REQUEST FOR COUNCIL ACTION

AGENDA SECTION: PUBLIC HEARINGS	ORIGINATING DEPT: PLANNING	ITEM NO. E-13
ITEM DESCRIPTION: Final Plat #03-07 to be known as Stonehedge Estates Second, by Stonehedge Land Development, LLC. The Applicant is proposing to subdivide approximately 21.34 acres of land into 51 lots for single family development and 2 Outlots. The Plat also proposes to dedicate new public roadways. The property is located north of East Circle Drive, east of the Northwood Hills Second Subdivision and allow for a connection to 35 th Street NE.		PREPARED BY: Theresa Fogarty, Planner

STONEHEDGE ESTATES SECOND SUBDIVISION

RE: Final Plat #03-07 to be known as Stonehedge Estates Second, by Stonehedge Land Development, LLC. The Applicant is proposing to subdivide approximately 21.34 acres of land into 51 lots for single family development and 2 Outlots. The Plat also proposes to dedicate new public roadways. The property is located north of East Circle Drive, east of the Northwood Hills Second Subdivision and allow for a connection to 35th Street NE.

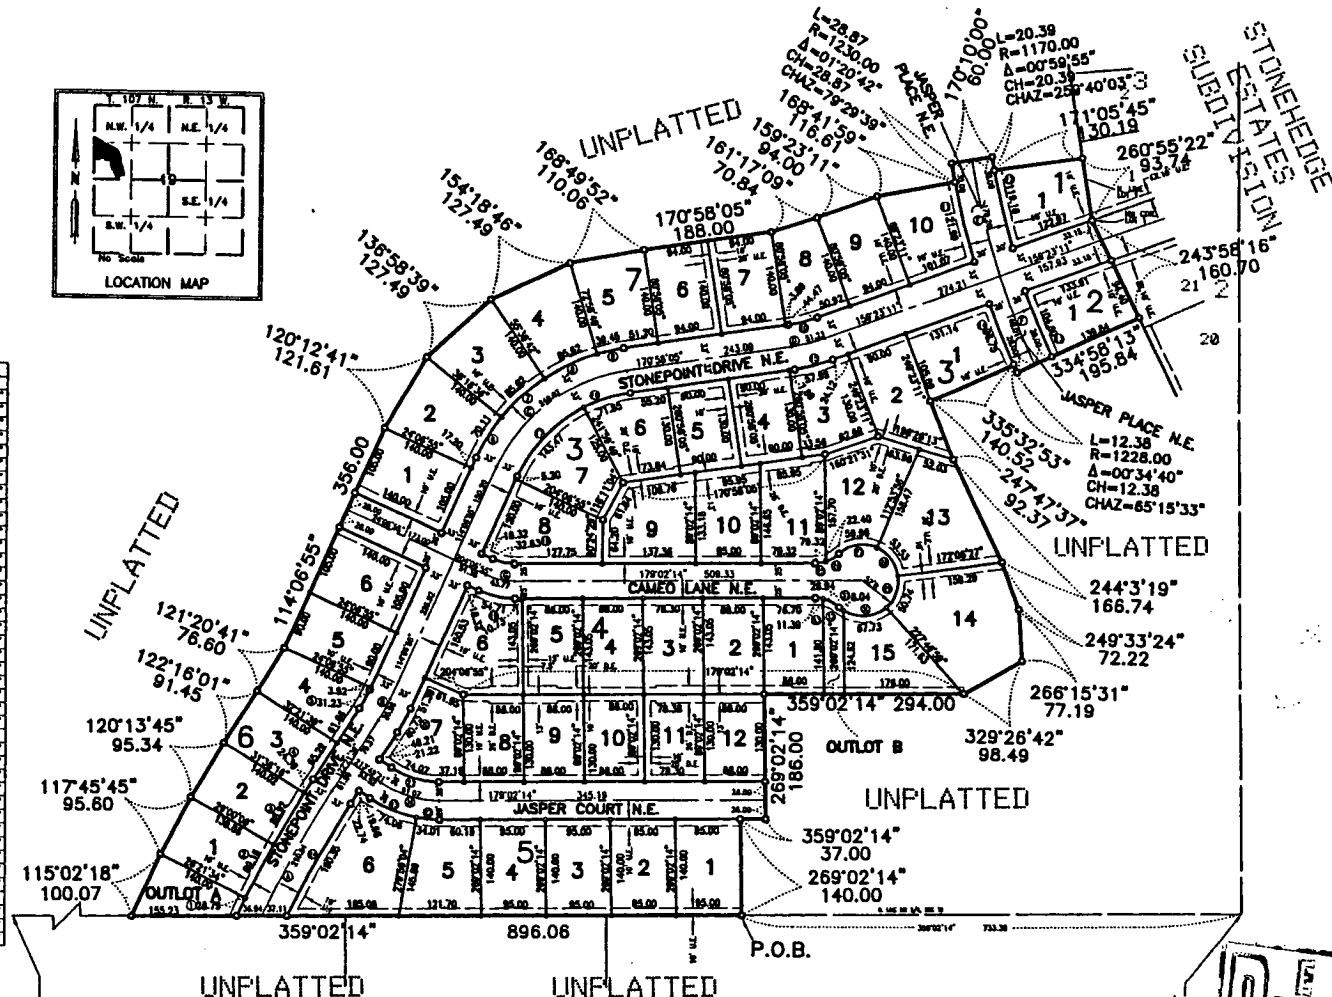
The first roadway labeled "Stonepoint Drive NE" is a continuation from the south and is designed with a 66' right-of-way. This roadway is illustrated incorrectly. Change Stonepoint Drive NE to "Stone Point Drive NE" (two words). The short stretch of roadway between Blocks 1 & 2 is missing the roadway designation. Label the portion of this roadway "Stone Point Drive NE". Construction of a temporary turn-around is required on the temporary easement that has been dedicated at the northerly extent of Stone Point Drive NE.

The fourth roadway labeled as "Jasper Place NE" is designed with a 60' right-of-way on the east side and a 56' right-of-way on the west of the intersection with Stonepoint Drive SE. The roadway running west from Stone Point Drive NE should be renamed to "Jasper Court NE".

The roadway located between Blocks 6 & 7 is missing the roadway designation. Label this roadway as "Cameo Place NE".

1. Stonepoint Drive as illustrated on Final Plat is incorrect. This roadway name was two words when platted in Stonehedge Estates.

2. Short stretch of roadway between Blocks one and two is missing the roadway designation.

- 250
3. Jasper Place NE illustrated between blocks two and three running west from Stone Point Drive NE has an incorrect roadway type.

4. Short stretch of roadway running northeast from Stone Point Drive NE between blocks Six and Seven is missing its designation.

1. ***Prior to recording, the final plat shall be revised, as follows:***
 - a. ***Change Stonepoint Drive NE to "Stone Point Drive NE" (two words).***
 - b. ***Label the roadway located between Blocks 1 & 2 as "Stone Point Drive NE".***
 - c. ***Change the roadway located between Blocks 2 & 3 labeled as Jasper Place NE to "Jasper Court NE".***
 - d. ***Label the roadway located between Blocks 6 & 7 as "Cameo Place NE".***

RECOMMENDATION: Change Stonepoint Drive NE to **STONE POINT DRIVE NE**. (Two Words)

RECOMMENDATION: Label roadway as **STONE POINT DRIVE NE**.

RECOMMENDATION: Roadway should be **JASPER COURT NE**.

RECOMMENDATION: Add roadway designation of **CAMEO PLACE NE**.
